## HISTORIC AND DESIGN REVIEW COMMISSION

**HDRC CASE NO:** 2023-211  
**ADDRESS:** 125 CITY ST  
**LEGAL DESCRIPTION:** NCB 971 BLK 5 LOT 10  
**ZONING:** RM-4, H  
**CITY COUNCIL DIST.:** 1  
**DISTRICT:** King William Historic District  
**APPLICANT:** Jonathan G Rodriquez | Vision Design Build  
**OWNER:** Jeanne and Douglas Robins  
**TYPE OF WORK:** Stucco removal and painting of masonry  
**APPLICATION RECEIVED:** May 16, 2023  
**60-DAY REVIEW:** July 15, 2023  
**CASE MANAGER:** Bryan Morales

### REQUEST:

2 RENOVATED FRONT ELEVATION  
A-10  $1/4"=1'-0"$

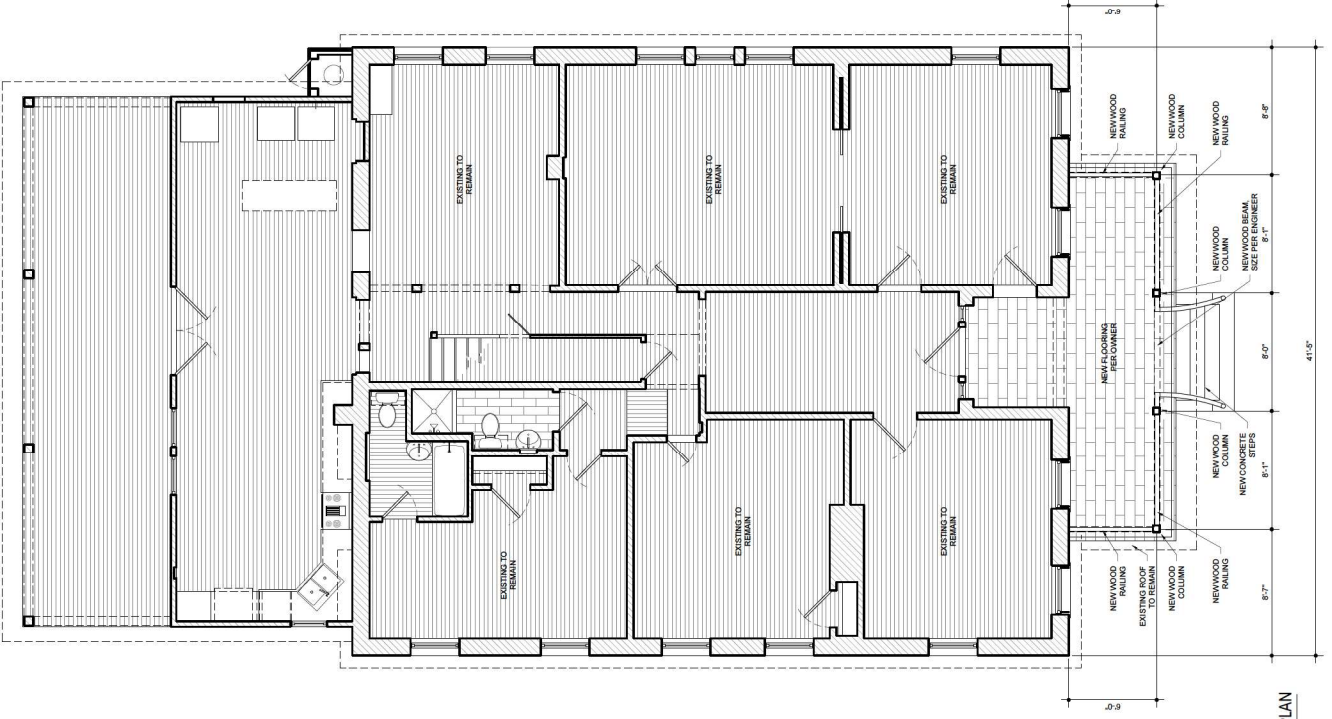
- c. MASONRY (STUCCO REMOVAL AND PAINT) – The applicant has proposed to remove non-original stucco from the front façade; the remaining façade feature painted brick. The stucco has been applied directly to the brick surface. Staff has concerns about the ability to remove the stucco without damaging the underlying brick. The applicant provided a test area for staff to consider which utilized a grinder to remove the stucco, thus permanently damaging the brick. While staff is not opposed to the concept of removing the stucco, staff remains concerned that the methodology proposed is not consistent with the Guidelines. Additionally, staff finds the painting of the exterior masonry to not conform to guidelines. Based on the information available, simply painting the stucco to match the previously-painted brick is likely the least invasive solution.

Staff does not recommend approval. Should the applicant provide a means for stucco removal that does not damage the underlying brick, staff recommends approval with the stipulation that the brick be repaired and remain unpainted consistent with the Guidelines.
